Staff Summary Report

SUBJECT: Hold a public meeting for a Development Plan Review for TACO BELL located at 1674 E. Southern Avenue.

DPR070112 – Development Plan Review including site plan, building elevations, and landscape plan.

SITE PLAN

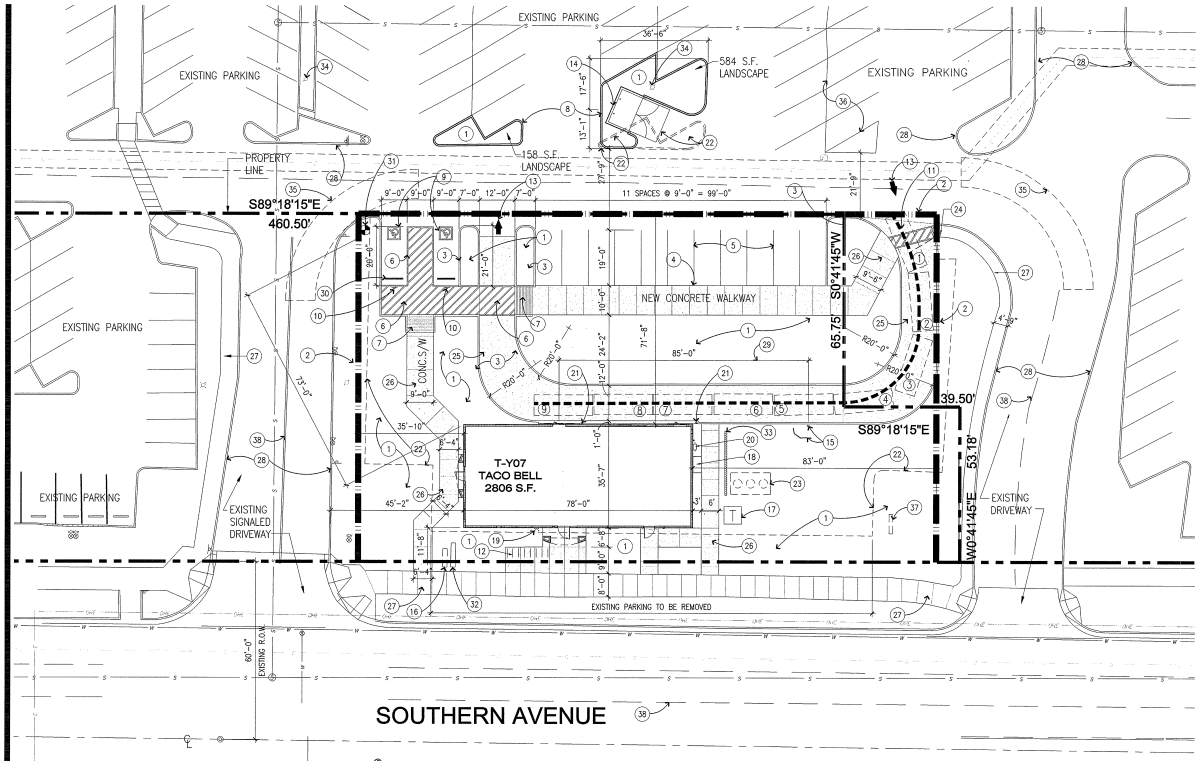
2. Provide 8'-0" wide public sidewalk along arterial roadways, or as required by Traffic Engineering Design Criteria and Standard Details.

3. Provide upgraded paving at each driveway apron consisting of unit paving. Extend unit paving in the driveway from the back of the accessible public sidewalk bypass to 20'-0" on site and from curb to curb at the drive edges.

4. Place exterior, freestanding reduced pressure and double check backflow assemblies in pre-manufactured, pre-finished, lockable cages (one assembly per cage). If backflow prevention or similar device is for a 3" or greater water line, delete cage and provide a masonry or concrete screen wall following the requirements of Standard Detail T-214.

14. Remove the 6’ screen wall shown on plan and elevation view. Locate the electrical service entrance section (S.E.S.) inside the building or inside a secure yard that is concealed from public view.

21. The proposed monument sign is not approved with this application, this requires a variance; make separate application for this entitlement process.

ELEVATIONS

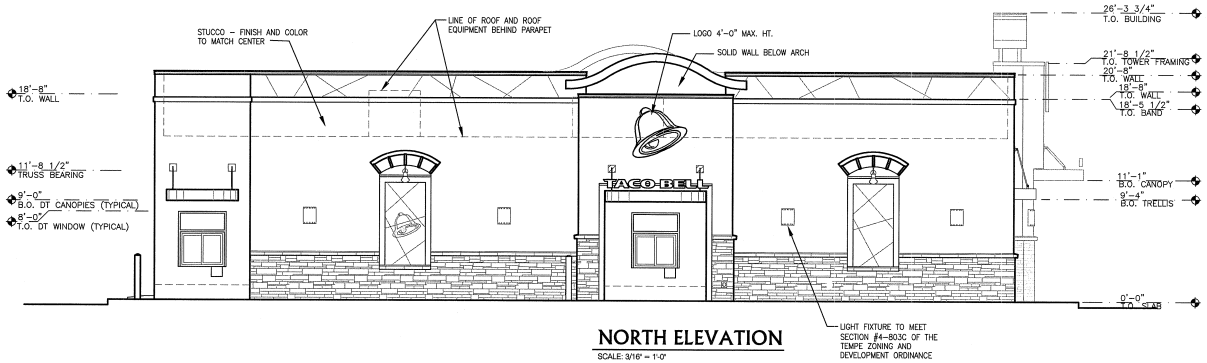
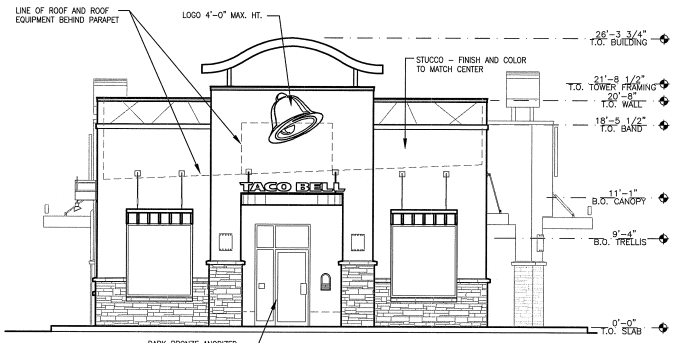
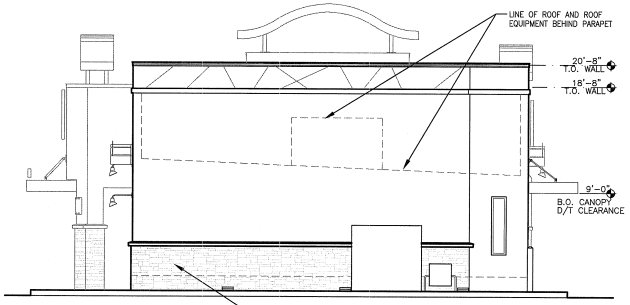
- Require that the architectural pop-out element shown on the south, north and west elevation be added to the east façade, to provide four sided architecture, as required by the General Plan of Development for this center and for aesthetic reasons. The east elevation could also use a faux window, although this is only a recommendation, not a condition.

- Require that the bell shown on the faux window and above the entrances be removed, these are sign elements which need to have separate review.
- Remove the faux window on the right side of the north elevation, and replace this with a real window into the dining room, for both aesthetic and security reasons. With all of the parking located on the north side of the building, and the only surveillance provided by the drive through window, staff determined that safety of the employees and customers would be enhanced with visual surveillance between the dining room and parking area. This would also benefit the security of the rest of the shopping center.

- Remove the arch element from the north elevation where the architectural pop-out is only 4". Most of the arched elements are located on top of pop out features that allow the arch to be free-standing from the building. The north side arched element conflicts with the accent band and the main body of the building.

- Remove the 6' screen wall and provide electrical and utility equipment internal to the building, not on the east façade, this is for both aesthetic and security reasons.

6. The architectural pop-out element shown on the south, north and west elevations shall also be added to the east façade, to provide four sided architecture, as required by the General Plan of Development for this center.

7. Remove the bell shown on the faux window and above the entrances, these are sign elements which need to have separate review.

8. Remove the faux window on the right side of the north elevation, and replace this with a real window into the dining room.

9. Remove the arch element from the north elevation where the architectural pop-out is only 4” and provide a continuous decorative band at the top of the building.

FLOOR PLAN

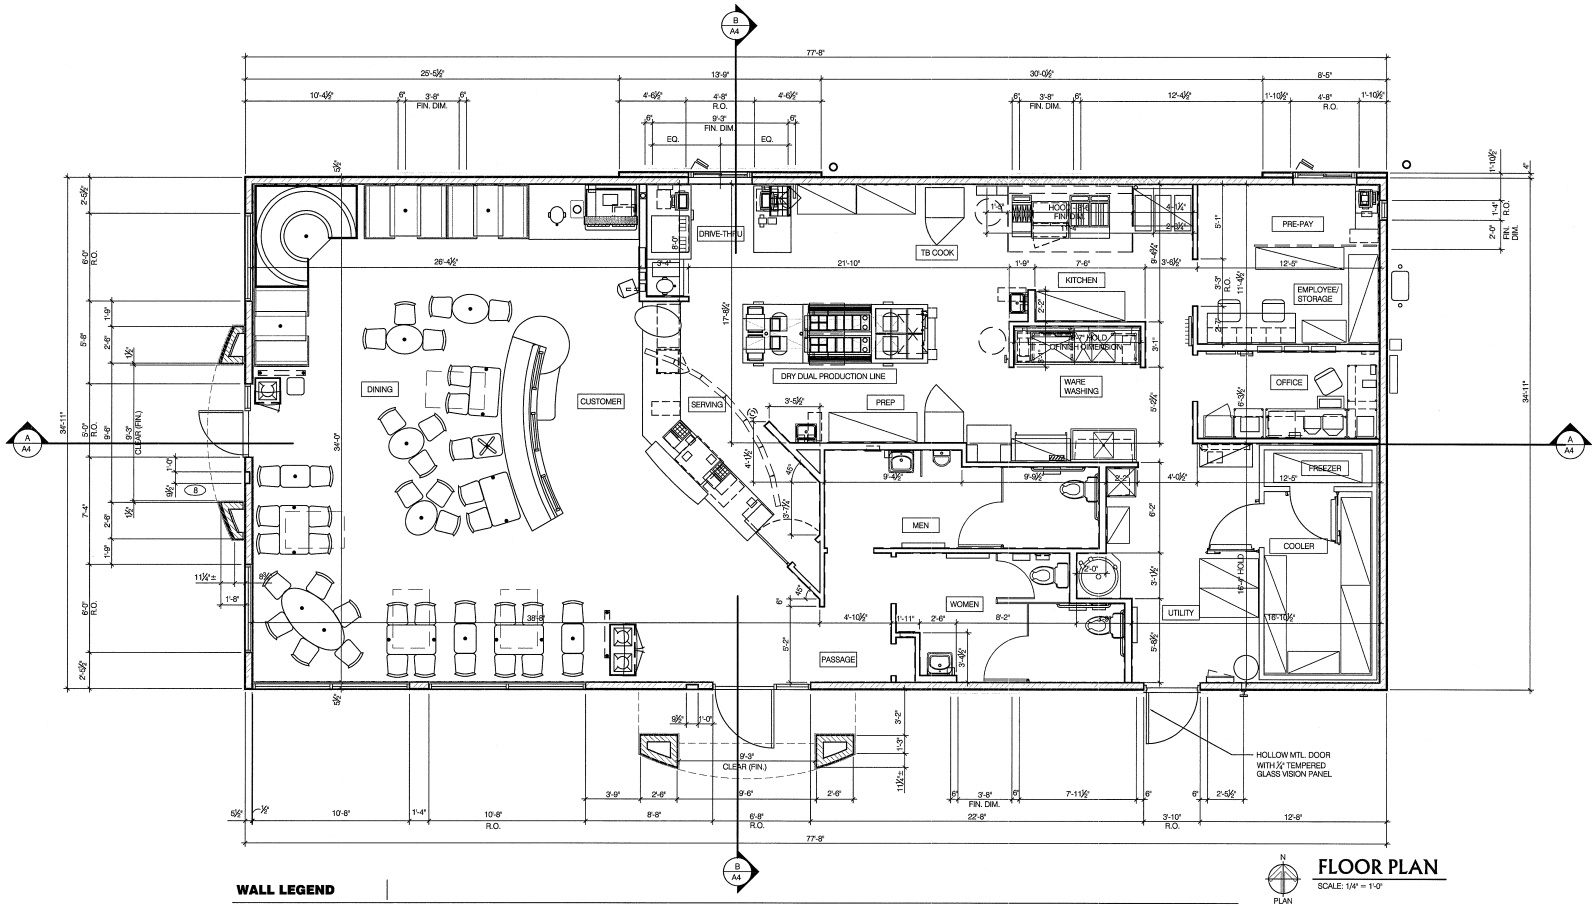
- A security vision panel shall be provided at service and exit doors (except to rarely accessed equipment rooms) with a 3” wide high strength plastic or laminated glass window, located between 43” and 66” from the bottom edge of the door.

PRELIMINARY LANDSCAPE PLAN

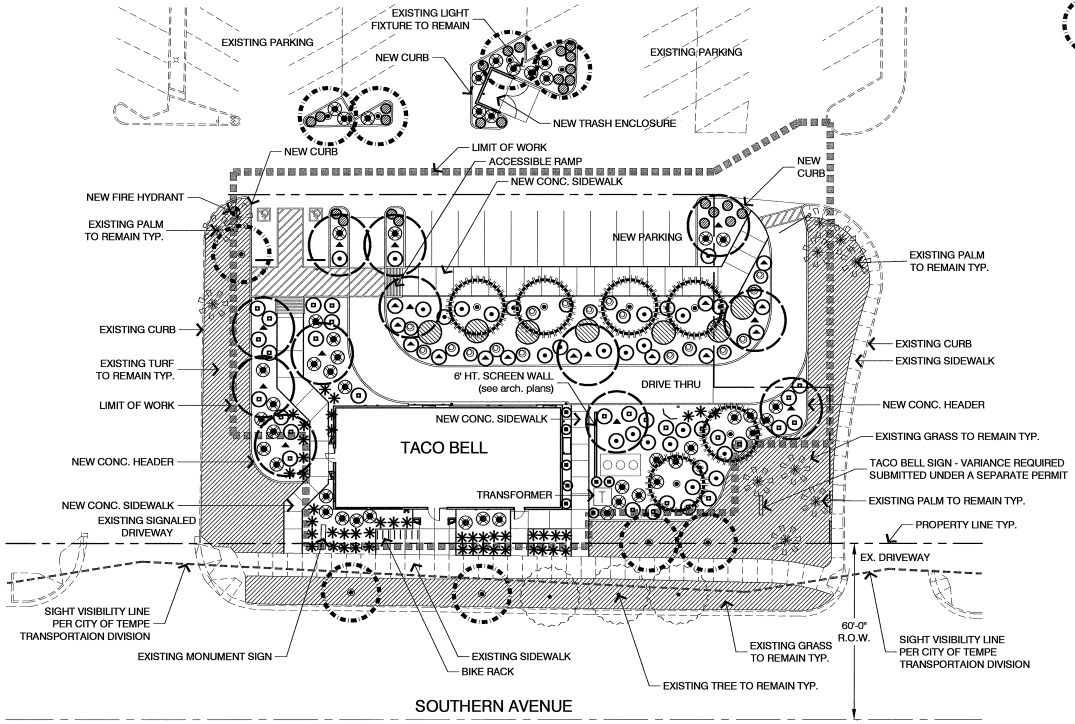
18. Irrigation notes:
    a. Provide dedicated landscape water meter.
    b. Enclose backflow prevention device in a lockable, pre-manufactured cage.
    c. Provide pipe distribution system of buried rigid (polyvinylchloride), not flexible (polyethylene). Use of schedule 40 PVC mainline and class 315 PVC ½” feeder line is acceptable. Class 200 PVC feeder line may be used for sizes greater than ½” (if any). Provide details of water distribution system.

19. Include requirement in site landscape work to de-compact soil in planting areas on site and in public right of way and remove construction debris from planting areas prior to landscape installation.

20. Top dress planting areas with a rock or decomposed granite application. Provide rock or decomposed granite of 2” uniform thickness or less. Provide pre-emergence weed control application and do not underlay rock or decomposed granite application with plastic.
